**Planning Department
Transportation Development Services**

**Re: Broadstone Cottonwood, 10800 Cibola Loop
Clubhouse, Fitness Center, Pool Area and Buildings 3 and 4
Submittal for Certificate of Occupancy – Transportation Development
Administrative Amendment dated 01-22-13 (A13-D022)
Certification dated 09-26-14**

A1.10

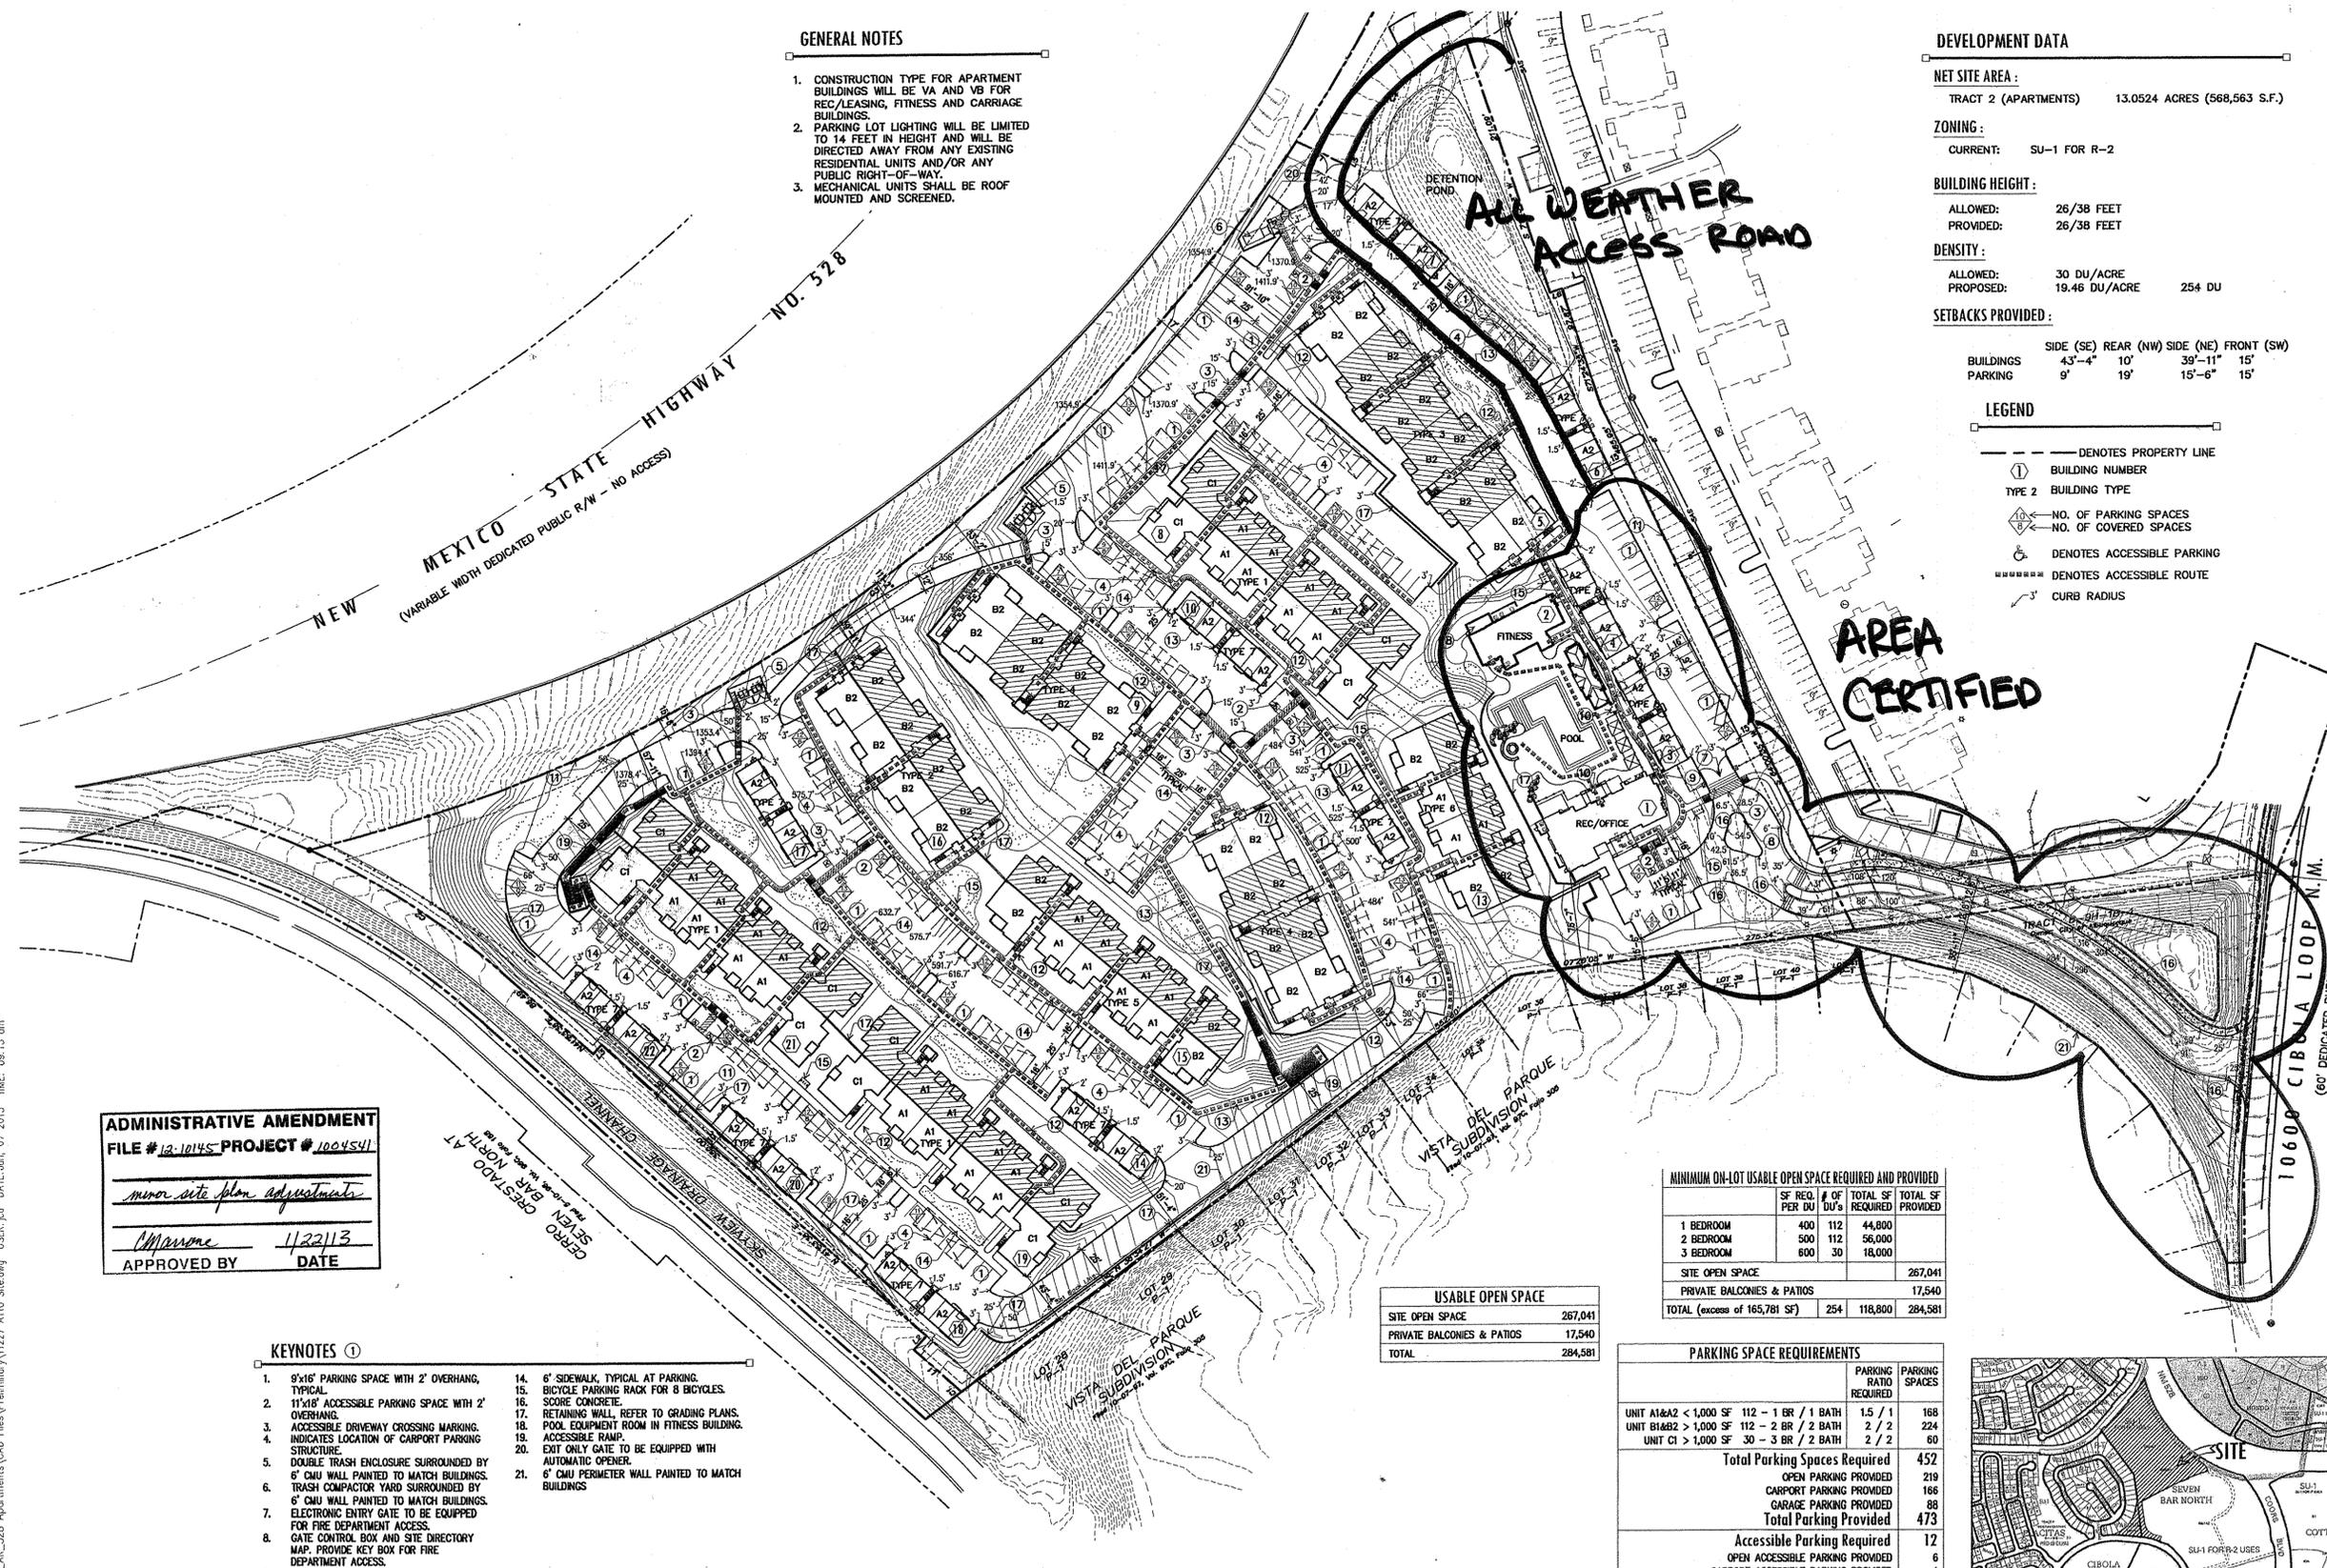
- The curb built near the ADA parking south of the Rec/Office has created a tripping hazard. Please remove and add curb bumpers in the parking spaces.
- Please provide a phasing plan that clearly shows the building numbers and the sequence of submittals.
